**WV ACE Partial State Plan
Appendix E
Public Participation**

Re: West Virginia CAA § 111(d) Partial Plan for
Greenhouse Gas Emissions from Existing Electric
Utility Generating Units (EGUs)

**West Virginia CAA §111(d) Partial Plan for Greenhouse Gas Emissions from Existing
Electric Utility Generating Units (EGUs)
RESPONSE TO COMMENTS**

Figure One. Longview Rolling Annual Average Emission Rates¹

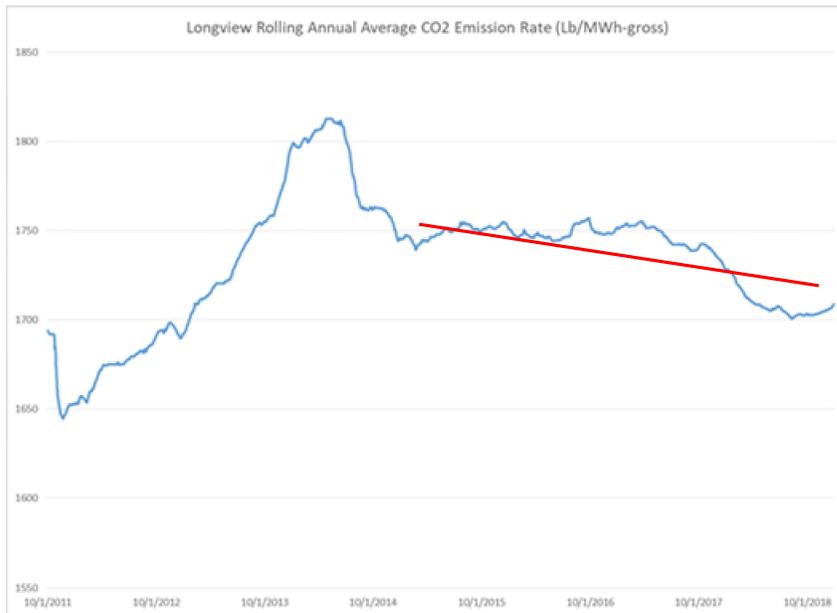
2) The inclusion of a Unit Degradation Adjustment Factor (page 11 of the Partial Plan) is based on the assumption of degraded performance as the plant ages (Table 4.4.b.3 of the Partial Plan), yet this assumption is contrary to observed facts. Longview’s own data (See Figure One, below) also show that, after initial startup issues were resolved, the emission rate improved over time (as some – but by no means all - of the recommended HRI technologies were adopted)

rather than degrading. It should also be understood that these rates include operation in all Load Bins and were achieved at a time when Longview’s operator was under no obligation to maintain a specific emission limitation and may have found it to be economically rewarding to operate in a fuel-inefficient manner. Thus, instead of seeking improvements in performance and reductions in emissions, the proposed limits in the draft Partial Plan would allow significant increases in greenhouse gas emissions. **Including emissions rates and UDAFs for plants that have not implemented the needed O&M is inappropriate.** The UDAF also allows the emissions rate increases to compound year-over-year, thus allowing much larger annual increases in later years. There does not appear to be any evidence to justify this, where it does occur, it shows a linear, not logarithmic, increase (even in plants not required to implement Heat Rate Improvements). **Since the goal is to limit greenhouse gas emissions, we recommend that the Partial Plan use lower rates for UDAF, provide better justification for any non-zero UDAF, and apply them only to the base year, rather than using a compound interest approach as currently proposed.**

Figure One. Longview Rolling Annual Average Emission Rates¹

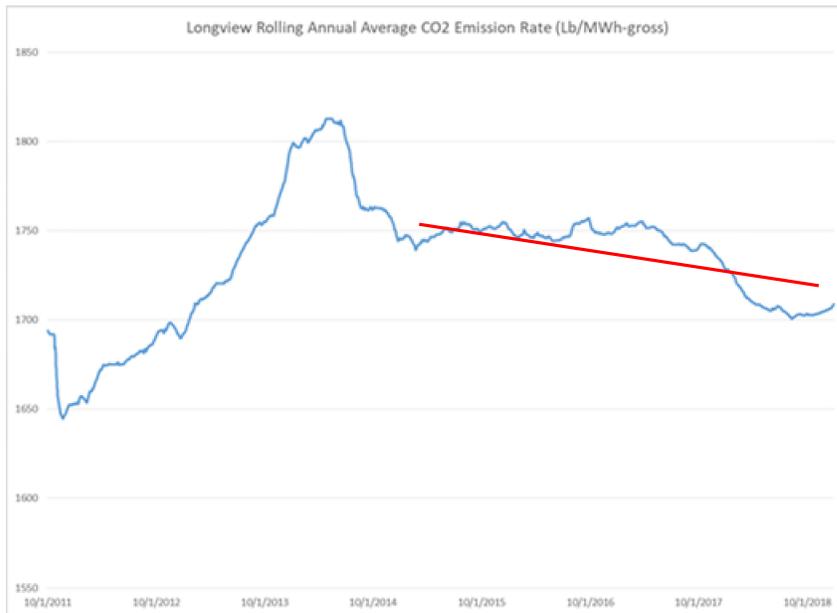
2) The inclusion of a Unit Degradation Adjustment Factor (page 11 of the Partial Plan) is based on the assumption of degraded performance as the plant ages (Table 4.4.b.3 of the Partial Plan), yet this assumption is contrary to observed facts. Longview’s own data (See Figure One, below) also show that, after initial startup issues were resolved, the emission rate improved over time (as some – but by no means all - of the recommended HRI technologies were adopted)

rather than degrading. It should also be understood that these rates include operation in all Load Bins and were achieved at a time when Longview’s operator was under no obligation to maintain a specific emission limitation and may have found it to be economically rewarding to operate in a fuel-inefficient manner. Thus, instead of seeking improvements in performance and reductions in emissions, the proposed limits in the draft Partial Plan would allow significant increases in greenhouse gas emissions. **Including emissions rates and UDAFs for plants that have not implemented the needed O&M is inappropriate.** The UDAF also allows the emissions rate increases to compound year-over-year, thus allowing much larger annual increases in later years. There does not appear to be any evidence to justify this, where it does occur, it shows a linear, not logarithmic, increase (even in plants not required to implement Heat Rate Improvements). **Since the goal is to limit greenhouse gas emissions, we recommend that the Partial Plan use lower rates for UDAF, provide better justification for any non-zero UDAF, and apply them only to the base year, rather than using a compound interest approach as currently proposed.**
